NO.	DESCRIPTION	DRAWN	CHKD	APPR.	DATE
12	REVISED PER EC 50103	CSS	PMR	KRW	8/29/02
11	AS BUILT PER MAR 96-11-03-01	TDF	DRG	LJS	11/4/99

REVISIONS					
FLORIDA POWER CORPORATION					
ST. PETERSBURG, FLORIDA					
UNIT NO. 3 CRYSTAL RIVER PLANT 855,000 KW					
ELECTRICAL MAIN CONTROL BOARD PSA					
PRIMARY SECONDARY AUXILIARIES ASSEMBLY					
FOR CONSTRUCTION BY					
ELBERT COMMERCIAL, INC.					
APPROVED					
NUCLEAR PROJECT MANAGER					
DATE	ENGR.	SCALE	WORK ORDER	REV.	FILE NO.
		3/4	5500	D-201-151	12 E-201-151
					9 W.O. 045500-064

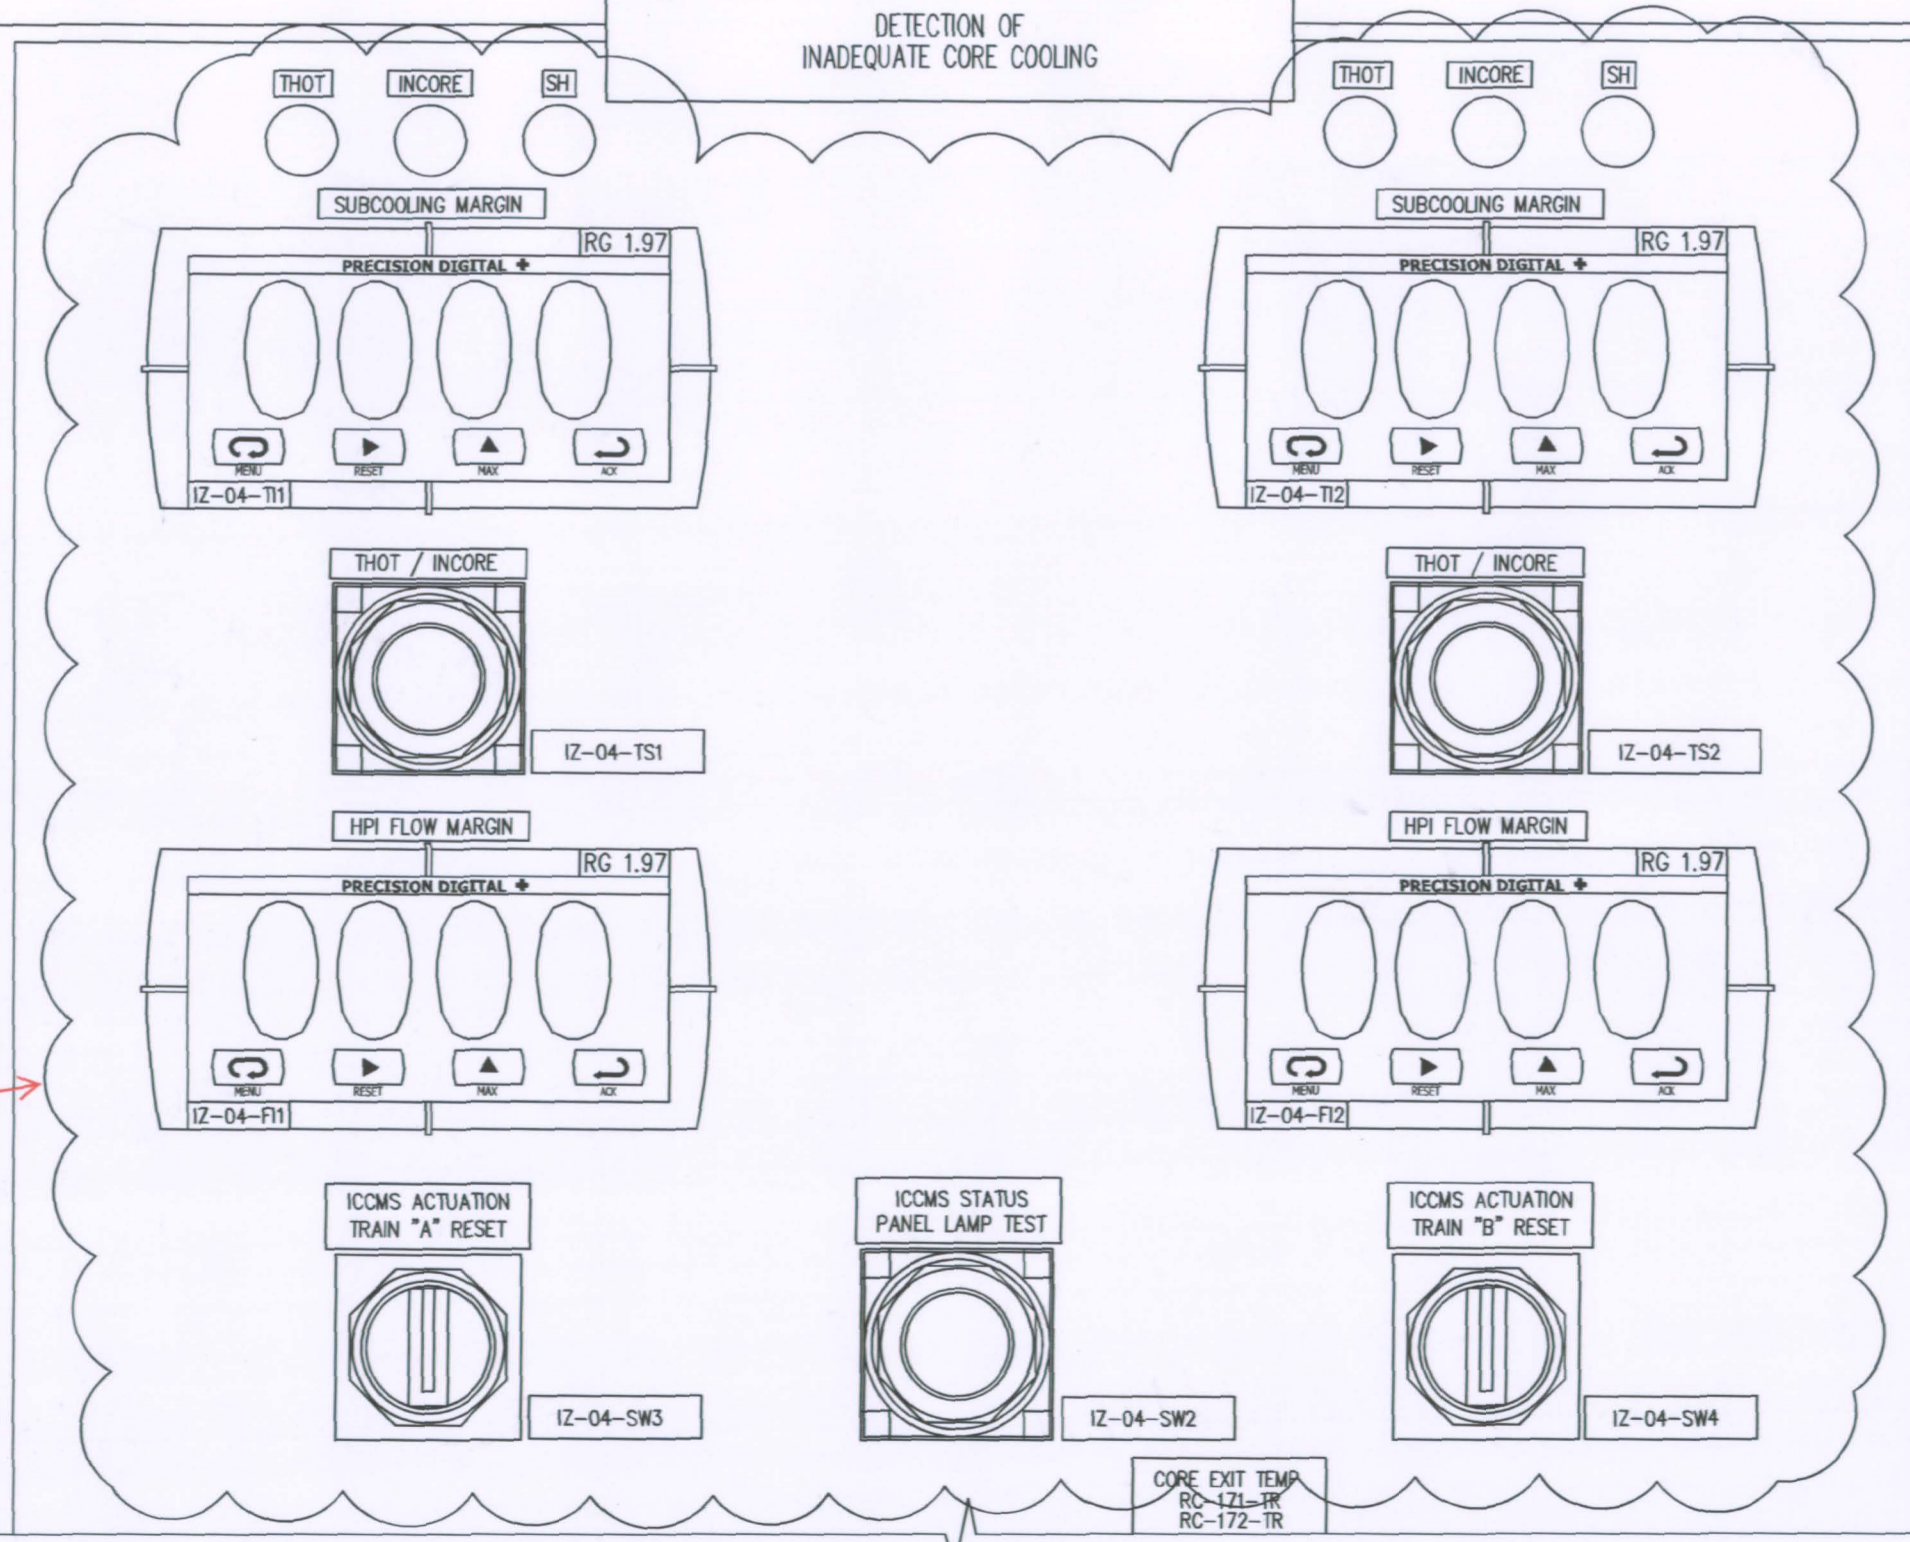
New ICCMS controls and indication. Relocating and consolidating existing indicators. Refer to 201-151 Sht. 5
